UNITED STATES PATENT AND TRADEMARK OFFICE

Office Action Summary

10/509,387

FRANCO, PASQUALINO

Attachment A

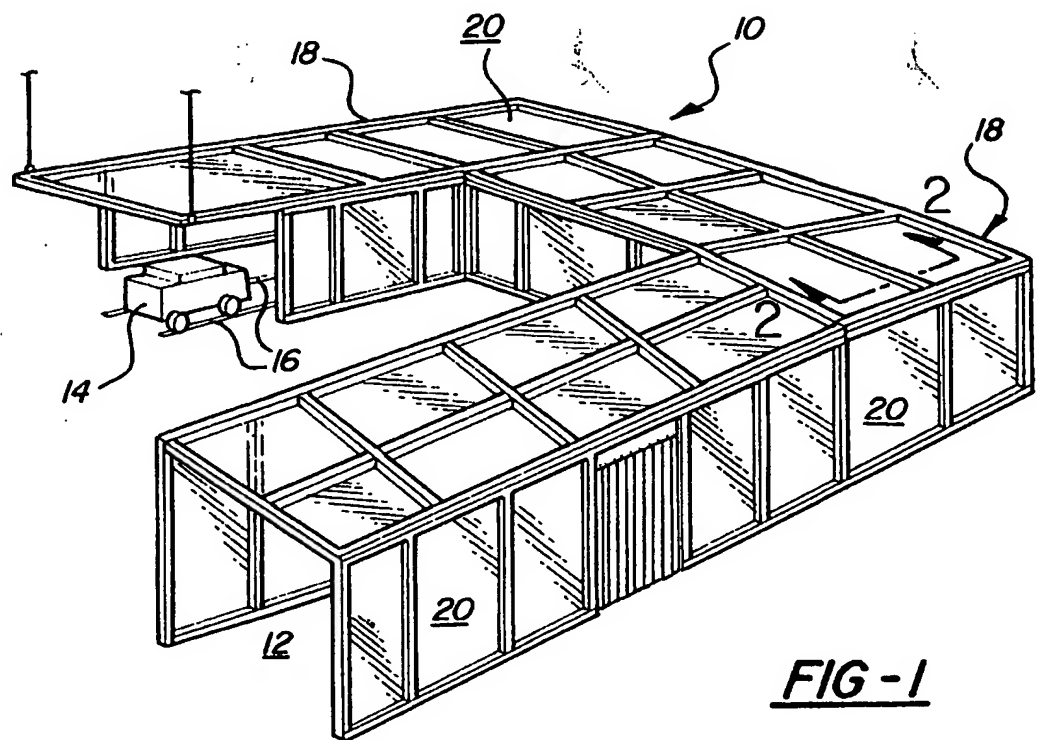
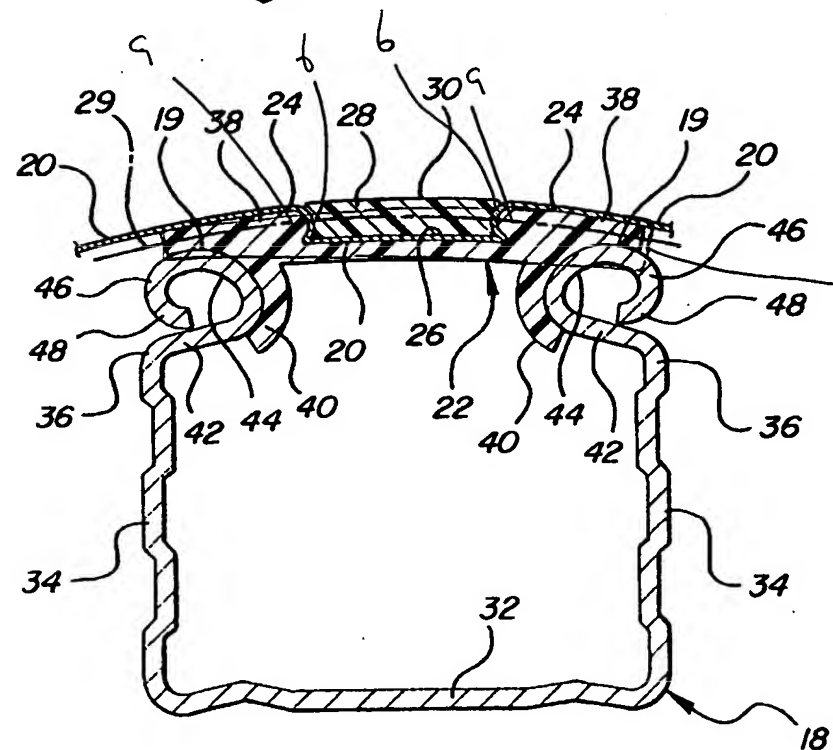
Claims 15 and 18 are rejected under 35 U.S.C. 103(a) as being unpatentable over by Lucous (4,410,027) in view of Weiss (3,229,029). Lucous teaches a flexible member attachment system (Fig. 2) comprising: a fixed element (15) having a rectangular shape (see Attachment A) with a hollow space, a "screw" hole (17) and projections (when viewing the top of the frame: the upper 25 and lower 32; the upper projection being longer than the lower one) and a mobile flat rectangular element (40; the inside end portion having a rectangular shape; see Attachment A) insertable into the inner space of the fixed element and being held in place by the projections extending into rounded notches on the mobile flat element. Note: the table, screw and cloth are not positively being claimed, the system having only to be capable of receiving a cloth (it is as shown by flexible sheet 12), having an opening capable of receiving a screw (opening receiving fastener capable of doing this) and capable of being placed on a table edge (it is because of its flat rear surface). Also, the feature description for the mobile element is open ended ("comprising"); therefore, additional members (outer members 41,43, etc. of 40) can also be part of the structure. Finally, the elements would inherently have proportional sizes relative to the window, a table inside the house, etc. For claim 15, Lucous fails to teach inner bulges on opposing sides of the hole of the fixed element. Weiss teaches the use of inner bulges (42) on the sides of a hole to help shield the fastener from other members. It would have been obvious to one having ordinary skill in the art at the time of the invention to modify the system of Lucous by

(Fig. 2) comprising: a fixed element (15) having a rectangular shape (see Attachment A) with a hollow space, a "screw" hole (17) and projections (when viewing the top of the frame: the upper 25 and lower 32; the upper projection being longer than the lower one) and a mobile flat rectangular element (40; the inside end portion having a rectangular shape; see Attachment A) insertable into the inner space of the fixed element and being held in place by the projections extending into rounded notches on the mobile flat element. For claim 24, Lucous fails to teach fixing elements on the mobile element. Bozzo teaches applying hooks and loops on a strip (20) to a structure so as to be able to attach a decorative cover (24) with mating hooks and loops (22) over the structure. It would have been obvious to one having ordinary skill in the art at the time of the invention to modify the system of Lucous by adding hooks and loops onto the outside of the mobile element, such as the strip taught by Bozzo, so that a decorative cover could be applied over the system for aesthetic reasons.

rectangular
inside portion

rectangular
fixed element with
hollow space &
rectangular shape

rectangular
fixed element
w/ hollow space
& rect. shape
